ARLINGTON COUNTY, VIRGINIA

County Board Agenda Item
Meeting of May 22, 2010

SUPPLEMENTAL REPORT ADDITIONAL INFORMATION AND REVISED RECOMMENDATION

SUBJECT: SP# 395 Site Plan Amendment to modify density, parking, height, facades, landscaping, utility locations, located at 3565 Lee Hwy.

LOWER GARAGE REVISED

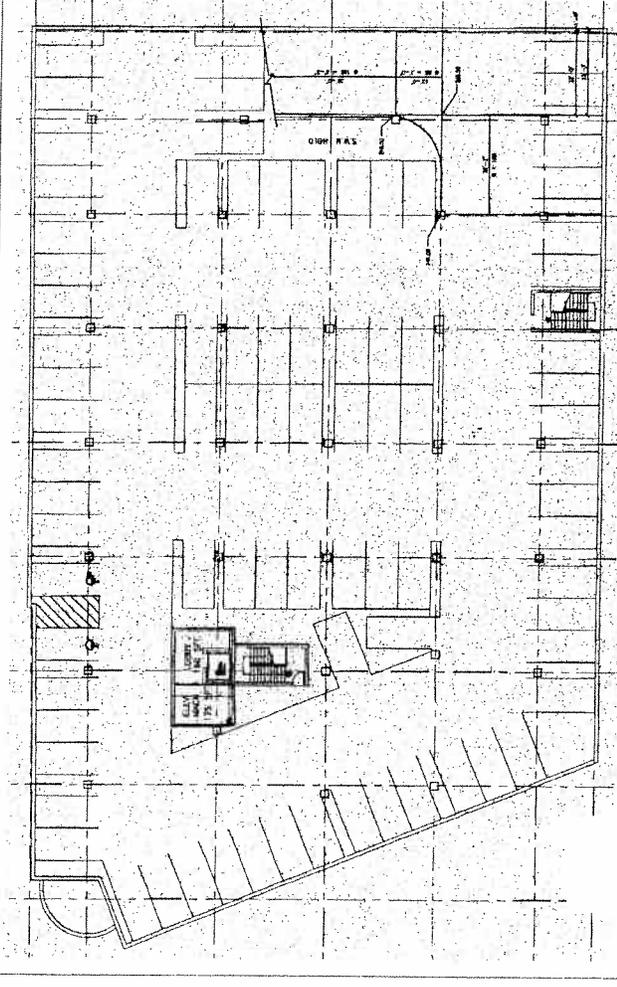
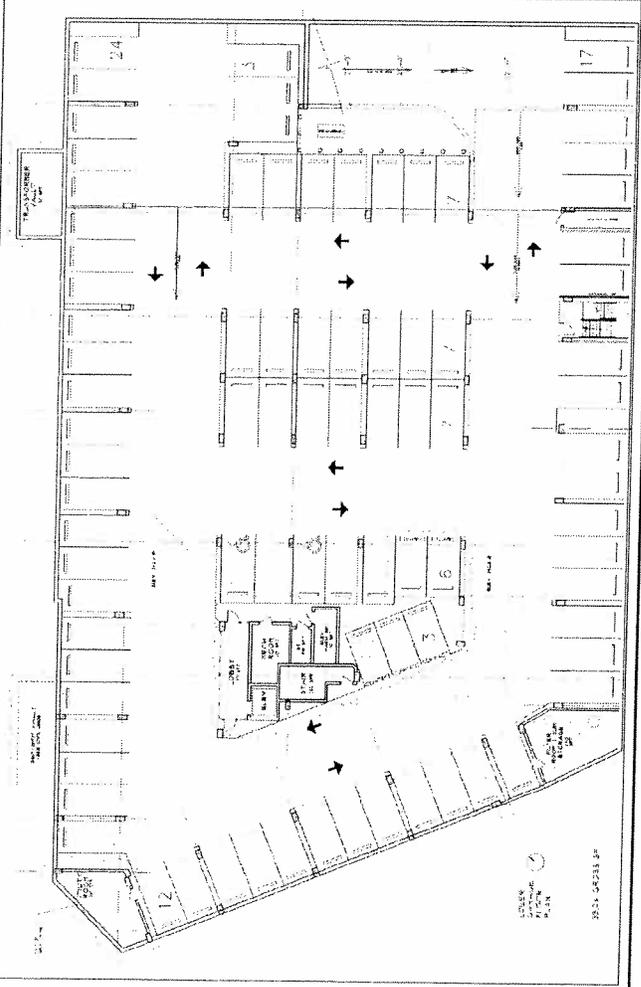
Approve the site plan amendment request for Site Plan #395 to modify density, parking, height, facades, landscaping, and utility locations, subject to revised Conditions #32, 37, 47, 49, 64, 70, and new Conditions #81, 82, and 83 in the County Manager's report dated May 14, 2010, revised Conditions #1, 17, 18, 19, and 62 as shown in this report, and all other previously approved conditions.

SOUTH ELEVATION APPROVED

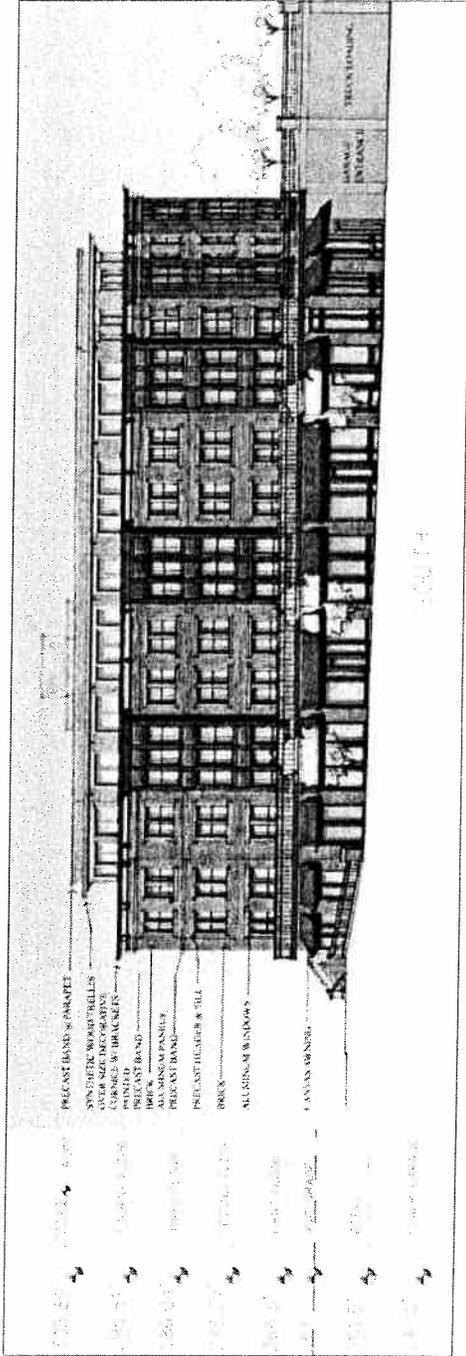
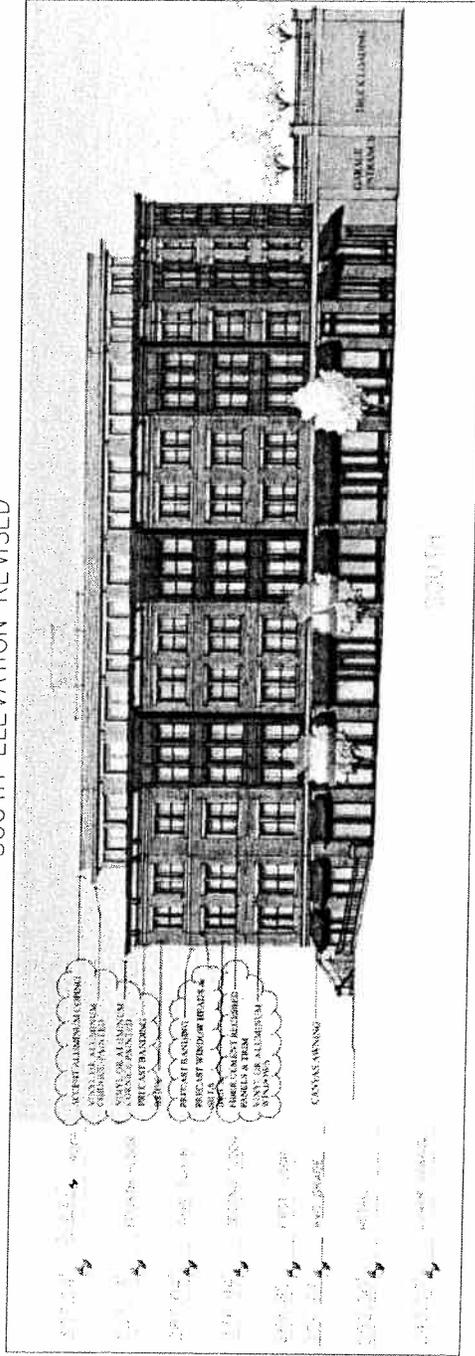
South Elevation Drawing: The developer had explored removing the corner plaza stairs during the site plan review process and revised the elevations for consistency. Since deciding to retain the approved plaza design, the elevation had not been corrected to show the opening in the retaining wall railing for the stairs. A corrected version has been submitted.
